**Brookhaven National Laboratory  
Plant Engineering - E&CS Division  
Engineering Change Notice Form**

**PROJECT:** CCWF II

**ECN Title:** Additional Conduits for Power to Future Chillers

**ECN No.** 51

DRAWN BY: BNK      DWG: EP-401

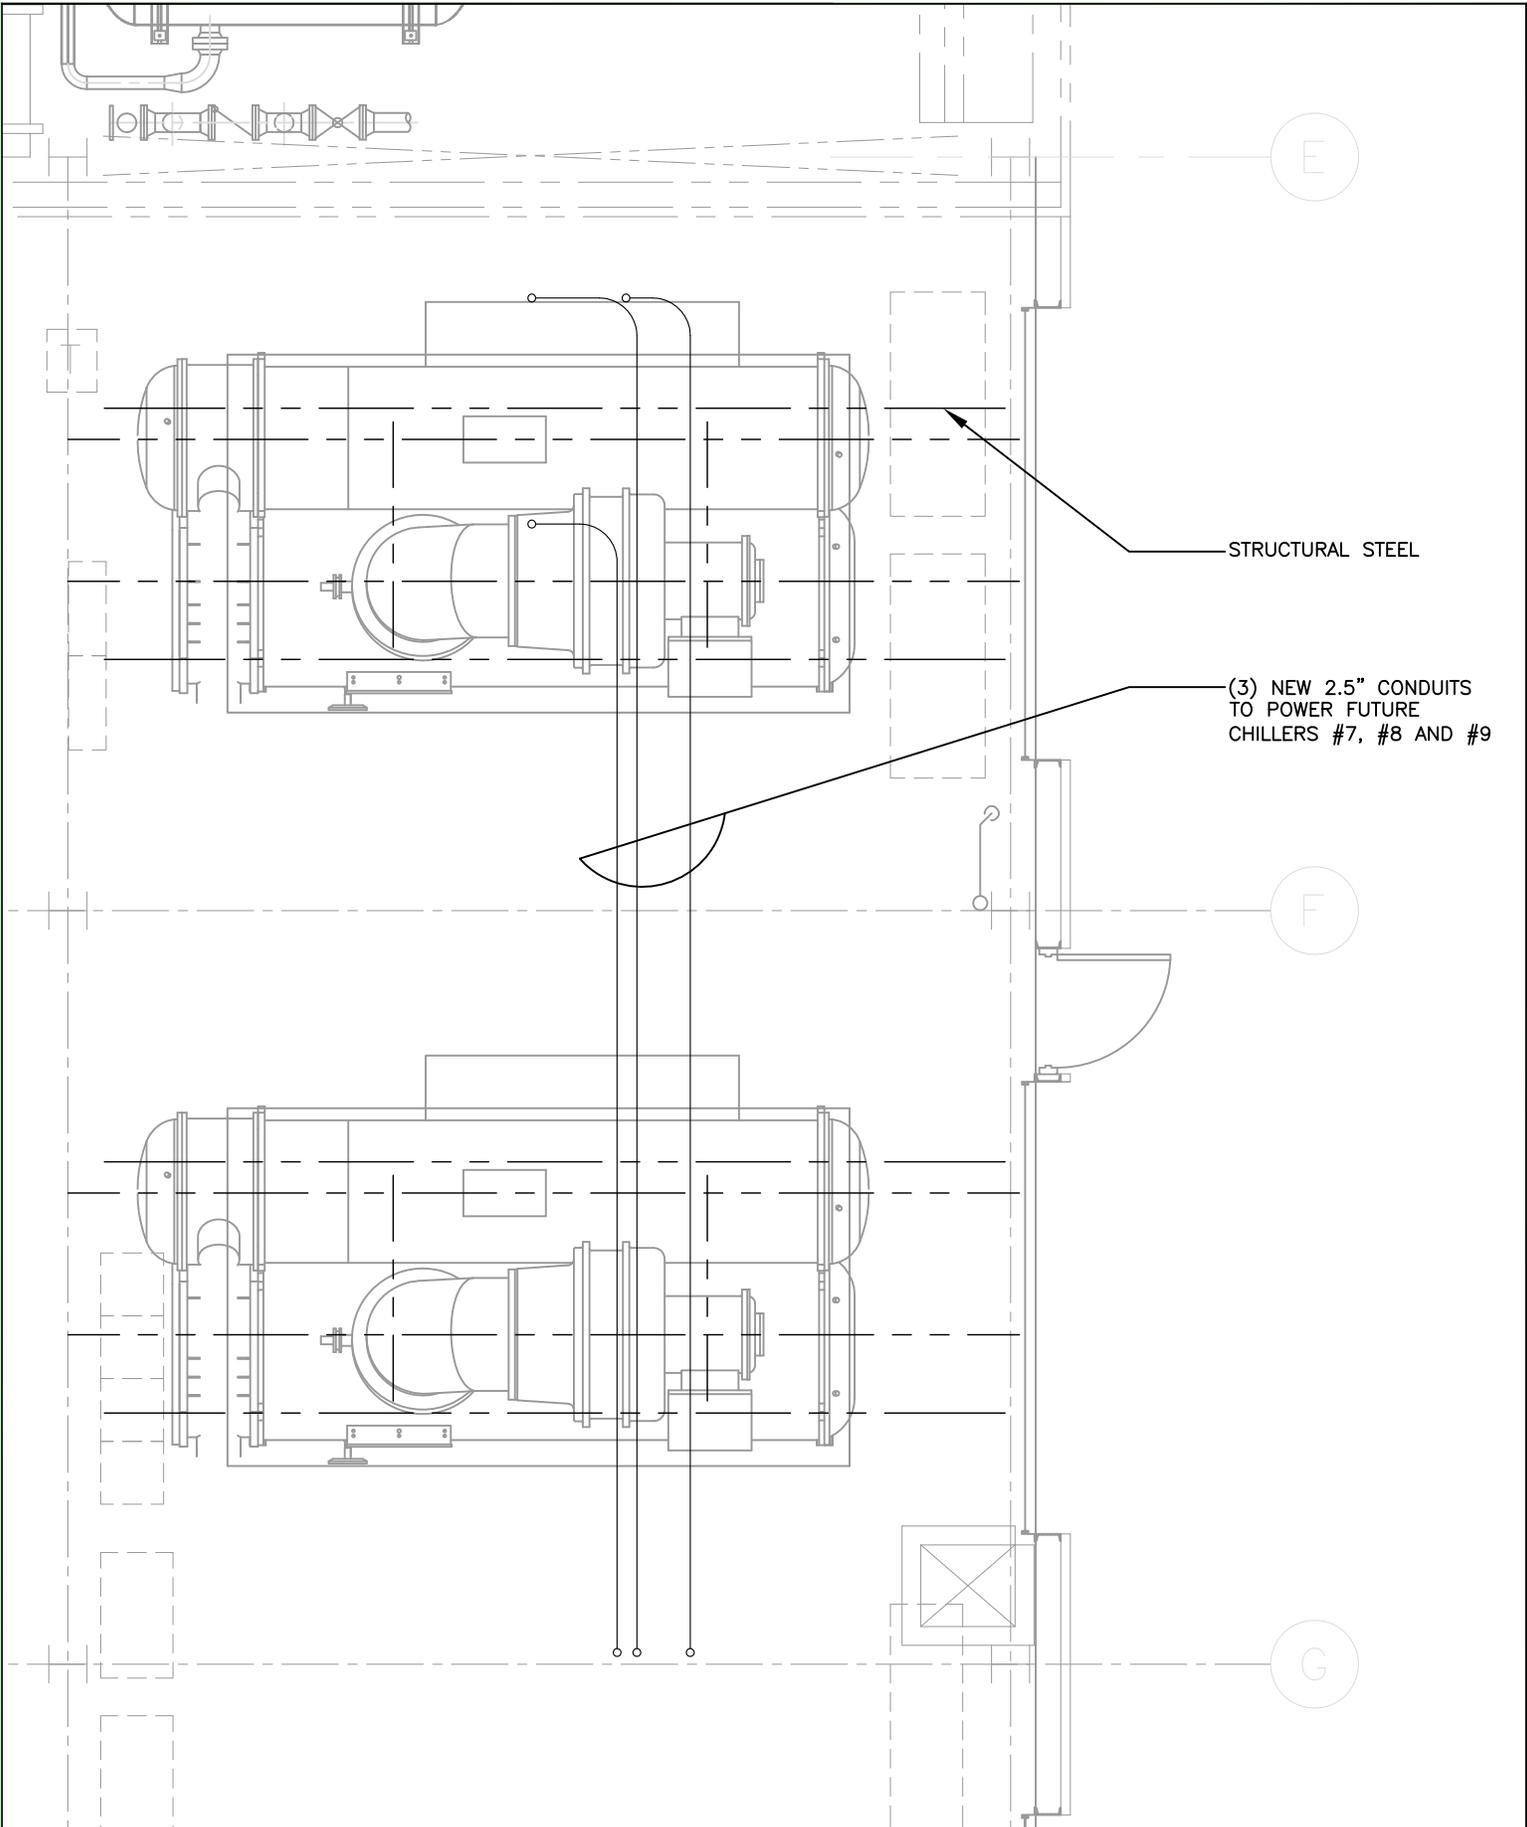
Requested Change (Attach sketch if applicable): Install 2.5" conduit to run power to the future chillers #7, #8, & #9 from the electrical mezzanine equipment to column line G above the operating floor.

(3) NEW 2.5" CONDUITS  
TO POWER FUTURE  
CHILLERS #7, #8 AND #9
